# Memorandum

**Date:** 16/03/2012

**SUBJECT: BROWSE LNG DEVELOPMENT – UNDERWATER NOISE MODELLING ASSESSMENT**

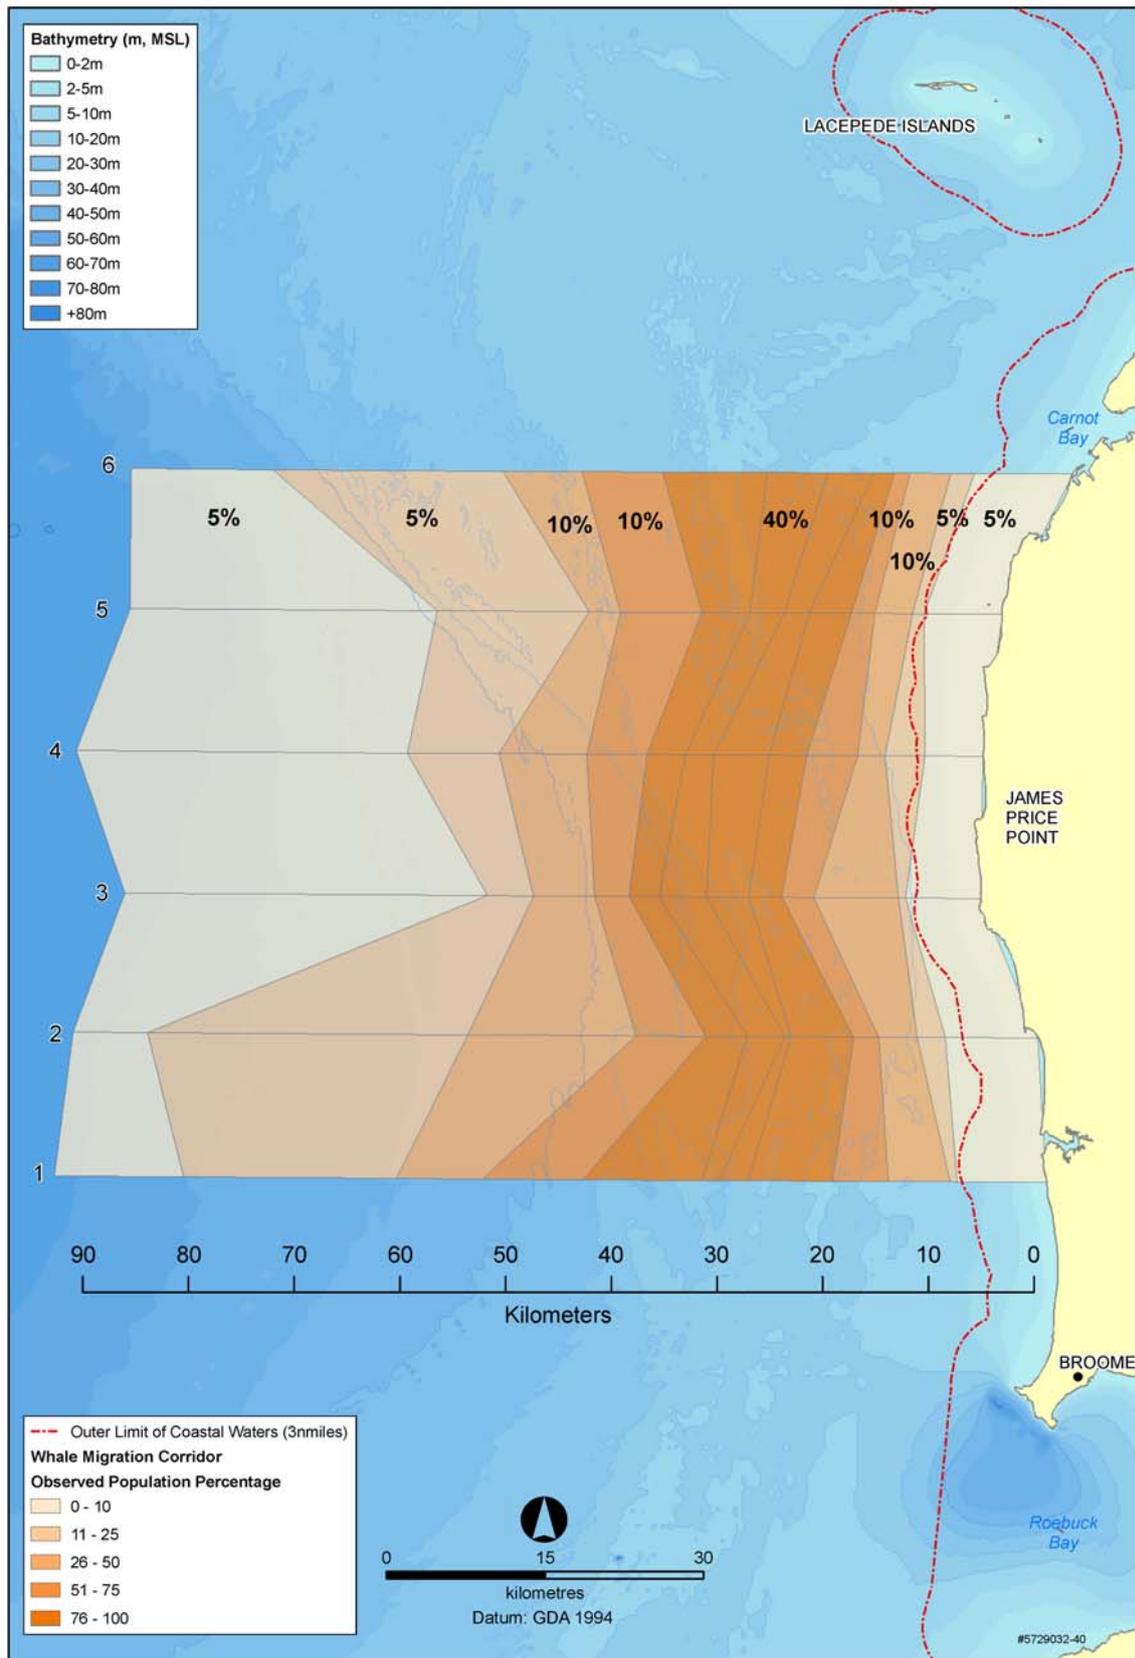
While it was acknowledged that humpback whales would be present off the Dampier Peninsula during the northerly and southerly migration periods, it was determined that the majority of animals (95%) were migrating at a distance of at least 8 km off the coast (**Figure 1**). With the data available at the time (i.e. 1 year worth of aerial surveys) the mean distance offshore during the migration for adults and calves was determined to be 27 km and 24 km respectively. Therefore, the data (RPS, 2010, **Appendix C-8**) indicated that approximately 5 % of the Group IV humpback whale population may migrate through the James Price Point coastal area (i.e. Coulomb Point to Quondong Point) during the migration season.

As stated in Section 2 of this memo, 95% of the total migratory humpback whale population were estimated to travel at a distance of at least 8 km off the coast (**Figure 1**). Data from the 2010 and 2011 megafauna surveys (RPS 2012) demonstrates the consistency in relative abundance of humpback whales in the migration corridor survey area between the survey years and confirms that the general spatial distribution of the humpback migration population is concentrated between 9 and 46 km offshore from the Dampier Peninsula coastline (Figure 2).

Figure 2. Total Number of Humpback Whales Recorded during the James Price Point Migration Corridor Survey 2009 (RPS 2010).

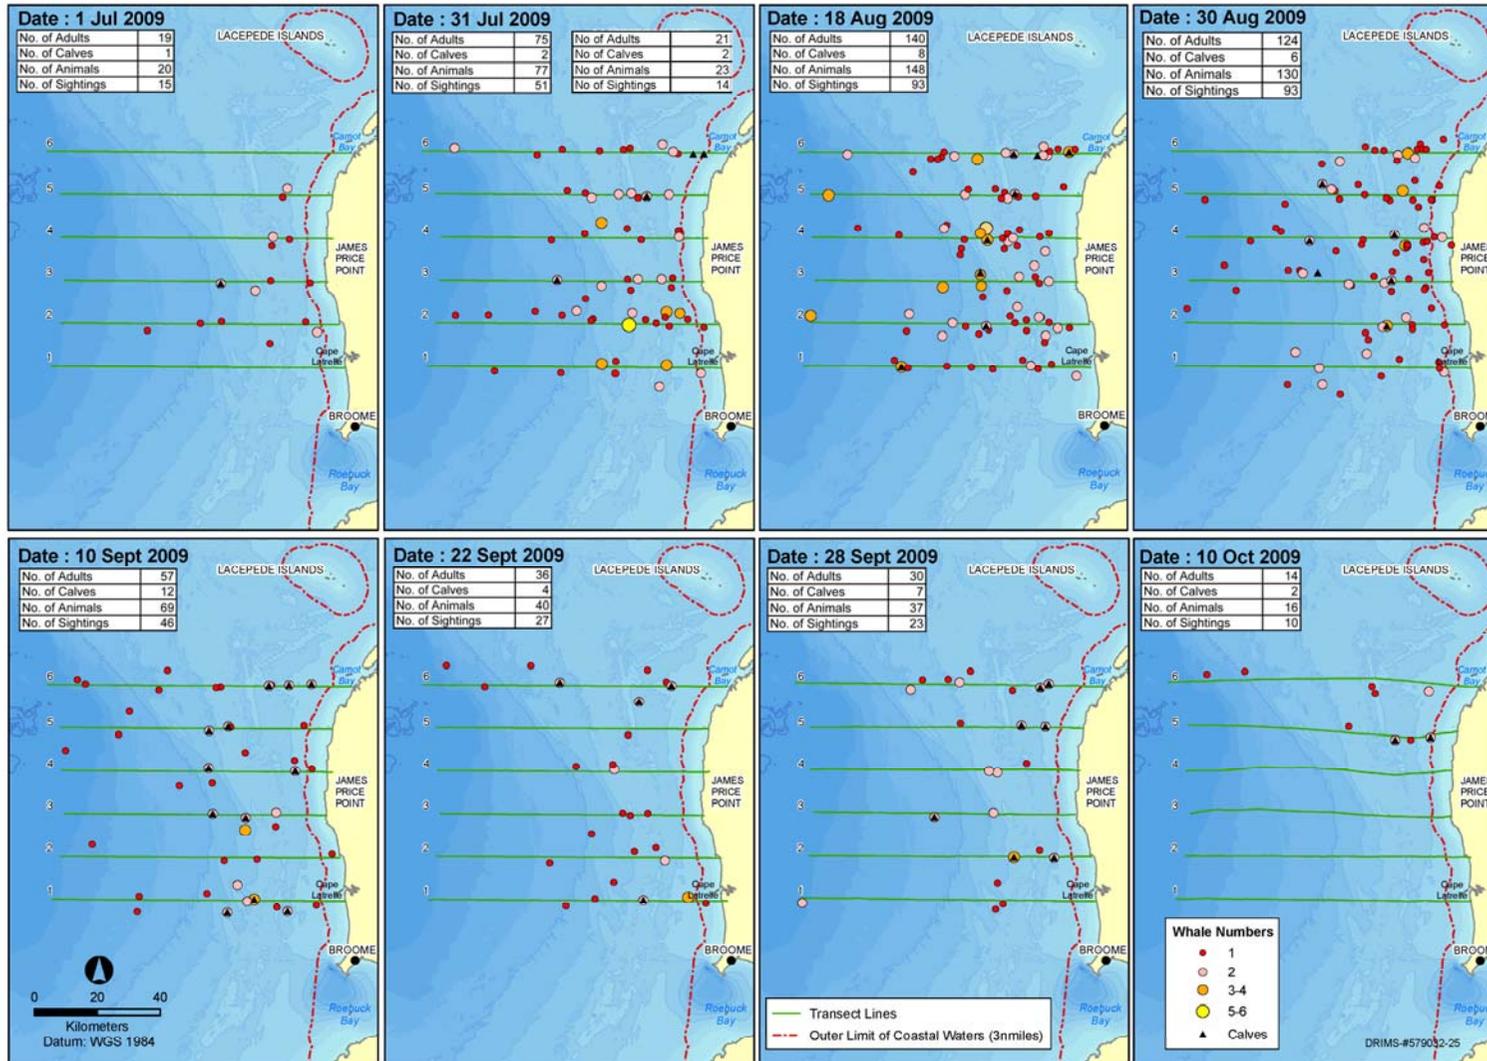
In addition, it was noted (RPS, 2010, **Appendix C-8**) that demonstrably fewer humpback whales were seen to travel along the coastal migration corridor on the southbound migration when the more vulnerable cow-calf groups would be present (**Figure 2**) (RPS, 2010; **Appendix C-8**). Consequently, it was concluded that the construction activities were unlikely to have a significant impact on the broader humpback whale population.
